Notice of Allowability

10/716,990

Inventor: KOMMA et al.
 Docket No.: 10873.1356US01
 Title: OPTICAL ELEMENT, OPTICAL LENS, OPTICAL HEAD APPARATUS, OPTICAL INFORMATION APPARATUS, COMPUTER, OPTICAL INFORMATION MEDIUM PLAYER, CAR NAVIGATION SYSTEM, OPTICAL INFORMATION MEDIUM RECORDER, AND OPTICAL INFORMATION MEDIUM SERVER
 Attorney Name: Douglas P. Mueller
 Phone No.: 612.455.3800
 Sheet 1 of 19
 REPLACEMENT SHEET

FIG. 2

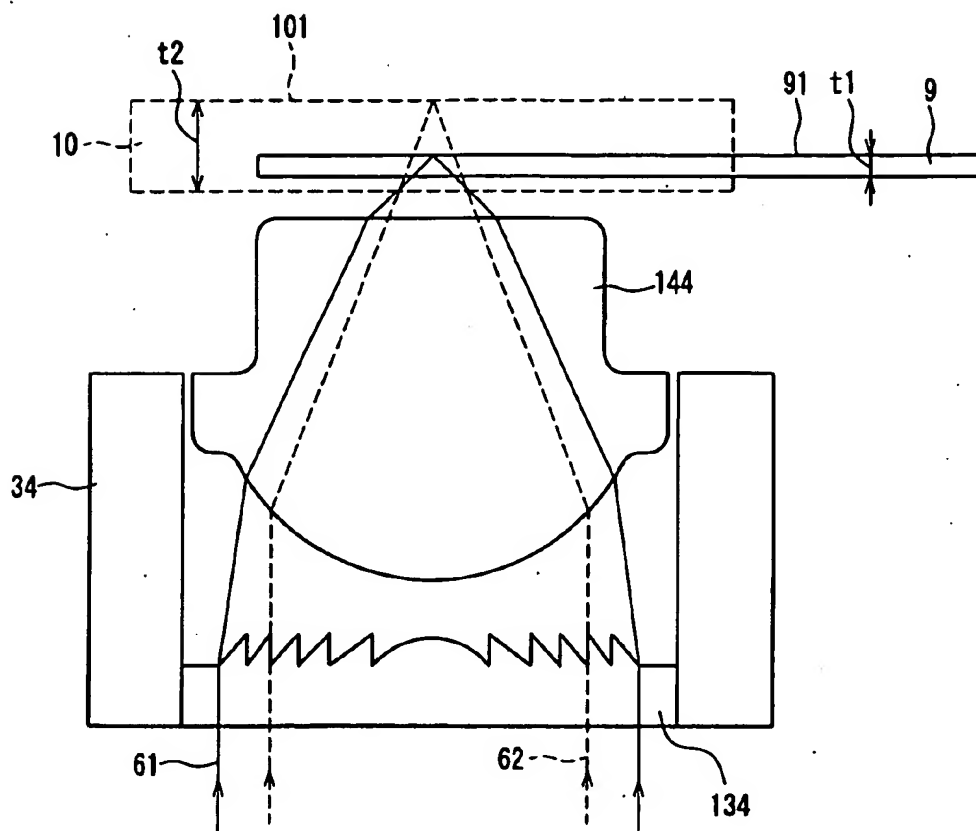
3. The replacement drawings were received on 10/31/06. These drawings are objected to for the following reason(s) as set forth below.
4. The drawings are objected to as failing to comply with 37 CFR 1.84(p)(5) because they include the following reference character(s) not mentioned in the description: Figures 2, 5, 7, 10, 13, 14- Reference numeral 34 (not all instances of '34' were removed in the replacement drawings submitted 10/31/06).

Corrected drawing sheets in compliance with 37 CFR 1.121(d), or amendment to the specification to add the reference character(s) in the description in compliance with 37 CFR 1.121(b) are required in reply to the Office action to avoid abandonment of the application. Any amended replacement drawing sheet should include all of the figures appearing on the immediate prior version of the sheet, even if only one figure is being amended. Each drawing sheet submitted after the filing date of an application must be labeled in the top margin as either "Replacement Sheet" or "New Sheet" pursuant to 37 CFR 1.121(d). If the changes are not accepted by the examiner, the applicant will be notified and informed of any required corrective action in the next Office action. The objection to the drawings will not be held in abeyance.
